MEMORANDUM

SUBJECT: Request for Feedback
141 Main Street, Unionville,
The Robert Harrington House
Installation of black metal railings on verandas
NH 23 114972

Property/Building Description: Historic former residence constructed 1873

Heritage Status: Designated under Part IV of the Ontario Heritage Act and identified as a Class 'A' in the Unionville Heritage Conservation District (building or buildings that define the heritage character of the district).

APPENDIX C – Photograph of the new metal railings

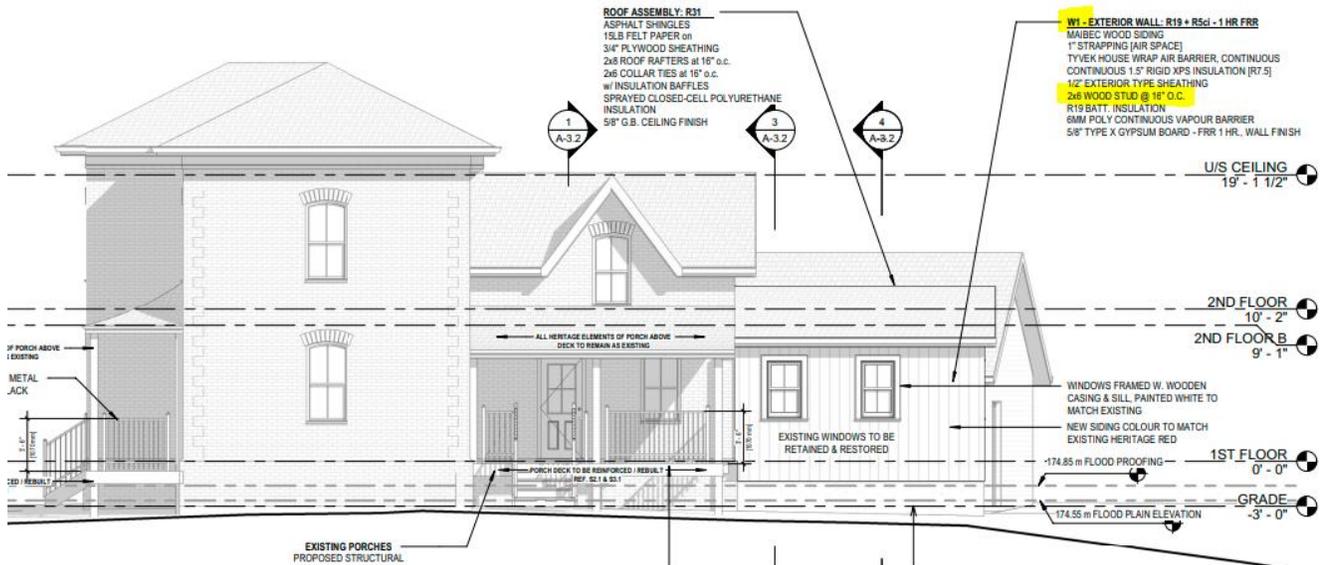
- Recently, simple black painted metal railings were installed on the front and side verandas at 141 Main St. Unionville (see photographs of the new railings);

- The applicant and their architect specified the simple metal railings that were installed on the verandas at 141 Main St. to make the property safer for people with disabilities, and because they felt that a simple, black, metal, code compliant railing would be less visible, while clearly not pretending to be a historic railing, and would have less of a negative impact on the appearance of the building, than a code compliant wooden railing composed of thicker components;

- Heritage Section Staff support maintaining open verandas which traditionally did not have railings. However, in this specific case where the OBC requires the introduction of a railing due to the reconstruction of the veranda decks, staff agree with the owner’s and architect’s rationale for selecting the railing they did, and share the opinion that a code compliant wooden railing painted either the same white colour as the historic veranda trims, or in black would be more detrimental than the look of the metal railing that was installed. Therefore it is recommend that the simple metal railing remain in place.

THAT Heritage Markham has no objection to the simple black railings installed on the verandas of 141 Main St. because they are required by the Ontario Building Code, and because they have less of a negative impact on the historic appearance of the building than a comparable, code compliant, wooden, railing of thicker material, painted either white or black.

APPENDIX D – Archival photograph of the house

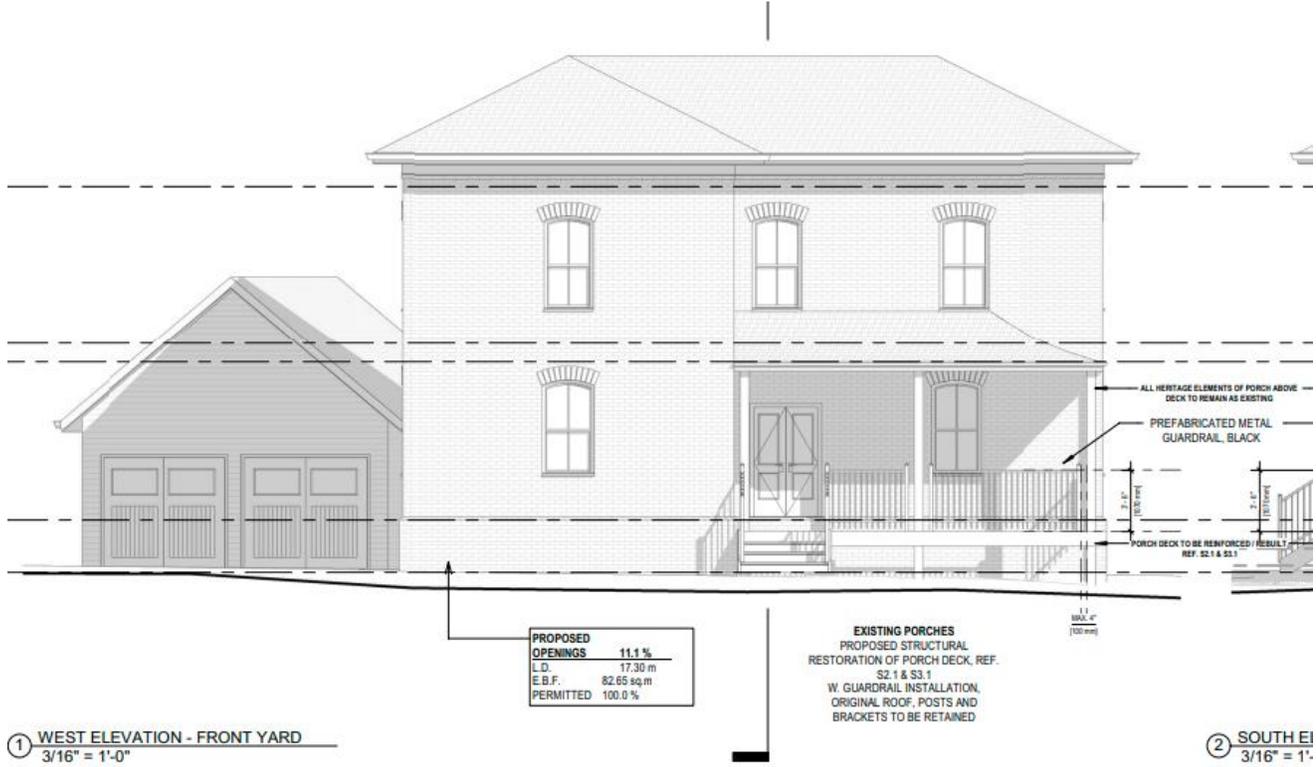
- Although both verandas of the house did not historically have railings (See archival photograph of the house), reconstruction of the veranda floor deck triggered the requirement to install railings compliant with the Ontario Building Code (OBC). Railings, were also desirable for the new, owners of the property who operate a Medical Office, because some of their patients are elderly, or have mobility issues, and they want to make the building as safe as possible for its users;
